Access Compliance Report

Public Rights-of-Way

(Curb Ramps)

Intersection ID: 28870	Main Street: AYRSHIRE_GLEN_PL	Cross Street: SHOPTON_RD	Location: SE
ADA ID: E54BC9C6C944	Ramp Type: BlendTrans2	Initial Pass/Fail: Fail	Overall Compliance: No
		Severity Score: 25

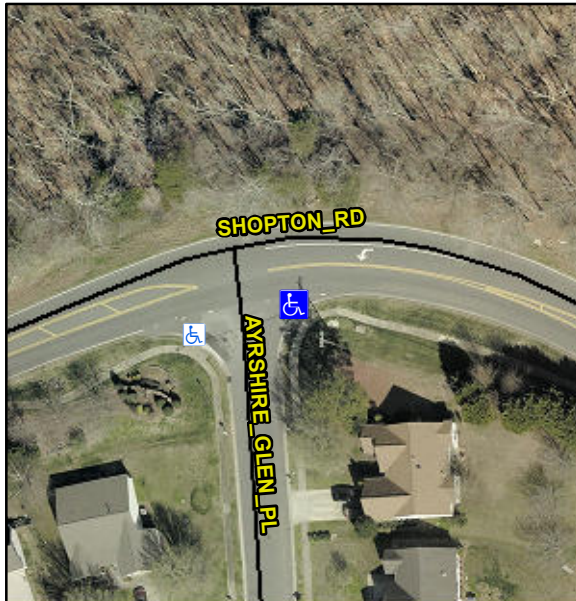
Not Found, R304.5.3

Compliance	Description	Data	Compliance	Description	Data
N/A	Ramp Length (in)	90.0	Yes	BlendTrans Slope (%)	3.5
Yes	Ramp Width (in)	48.0	No	BlendTrans XSlope (%)	8.7
N/A	Flare Type LT	N/A	N/A	Flare Type RT	N/A
N/A	Flare Slope LT (%)	N/A	N/A	Flare Slope RT (%)	N/A
N/A	Flare Traversable LT?	N/A	N/A	Flare Traversable RT?	N/A
N/A	Landing Length (in)	N/A	N/A	DWS Provided?	N/A
N/A	Landing Width (in)	N/A	N/A	DWS Contrast?	N/A
N/A	Landing Slope (%)	N/A	N/A	DWS Length (in)	N/A
N/A	Landing X Slope (%)	N/A	N/A	DWS Full Width?	N/A
N/A	Landing Curb? (Y/N)	N/A	N/A	DWS Offset (in)	N/A
N/A	Shared Landing?	N/A			
N/A	Gutter Ponding?	N/A	N/A	Gutter Slope (%)	N/A
N/A	Gutter Lip Ht (in)	N/A	N/A	Gutter X Slope (%)	N/A
N/A	Painted X Walk1?	No	N/A	Painted X Walk2?	No
	X Walk 1 Direction	To N		X Walk 2 Direction	To W
	X Walk 1 Width (in)	N/A		X Walk 2 Width (in)	N/A
	X Walk 1 Slope (%)	1.5		X Walk 2 Slope (%)	6.3
	X Walk 1 X Slope (%)	8.5		X Walk 2 X Slope (%)	0.9

N/A	Ramp inside XWalk1?	N/A	N/A	Ramp inside XWalk2?	N/A
	Road Slope (%)	5.0		Clear Space?	N/A
	Road X Slope (%)	5.5	N/A	Clear Space to XWalk (in)	N/A
N/A	Any Obstructions?	N/A	N/A	Storm Grate/Utility Hazard?	N/A
	Obstruction Type			Storm Grate/Utility Type	
		N/A			N/A
			Yes	Surface Condition? (G/P)	Good
			No	Curb Slope (%)	23.2

Remove & Replace Curb Ramp With Two New Directional Ramps or Equivalent.
